# Access Compliance Report

## Public Rights-of-Way

Intersection ID: 10031127	Main Street: MARGARET_WALLACE_RD	Cross Street: N/A	Location:	N
ADA ID: 12052F2F04AB	Ramp Type: Perp	Initial Pass/Fail: Fail	Overall Compliance: No	Severity Score: 10
Codes/Mitigation Info/Possible Solution		Field Measurements/Component Compliance

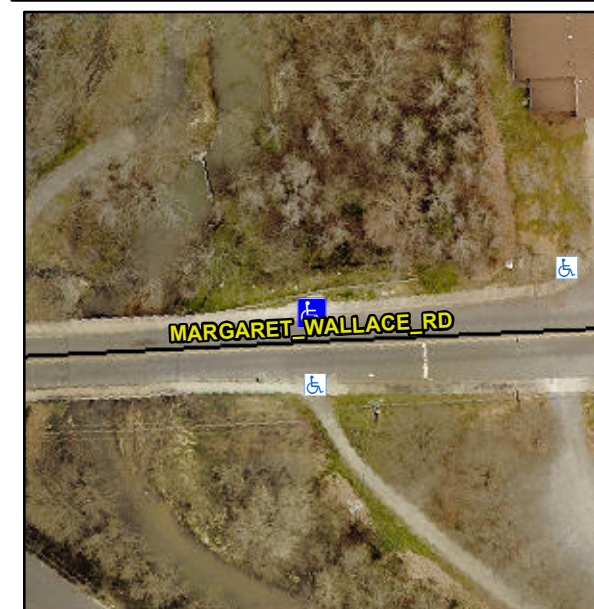
**Not Found, R304.5.1, R304.5.3**

Compliance	Description	Data	Compliance	Description	Data
N/A	Ramp Length (in)	72.0	Yes	Ramp Slope (%)	7.1
No	Ramp Width (in)	47.0	No	Ramp XSlope (%)	4.4
N/A	Flare Type LT	N/A	N/A	Flare Type RT	N/A
N/A	Flare Slope LT (%)	N/A	N/A	Flare Slope RT (%)	N/A
N/A	Flare Traversable LT?	N/A	N/A	Flare Traversable RT?	N/A
N/A	Landing Length (in)	N/A	N/A	DWS Provided?	N/A
N/A	Landing Width (in)	N/A	N/A	DWS Contrast?	N/A
N/A	Landing Slope (%)	N/A	N/A	DWS Length (in)	N/A
N/A	Landing X Slope (%)	N/A	N/A	DWS Full Width?	N/A
N/A	Landing Curb? (Y/N)	N/A	N/A	DWS Offset (in)	N/A
N/A	Shared Landing?	N/A			
N/A	Gutter Ponding?	N/A	N/A	Gutter Slope (%)	N/A
N/A	Gutter Lip Ht (in)	N/A	N/A	Gutter X Slope (%)	N/A
N/A	Painted X Walk1?	No	N/A	Painted X Walk2?	N/A
	X Walk 1 Direction	To S		X Walk 2 Direction	N/A
N/A	X Walk 1 Width (in)	N/A	N/A	X Walk 2 Width (in)	N/A
	X Walk 1 Slope (%)	5.5		X Walk 2 Slope (%)	N/A
	X Walk 1 X Slope (%)	2.7		X Walk 2 X Slope (%)	N/A

**Remove & Replace Entire Ramp.**
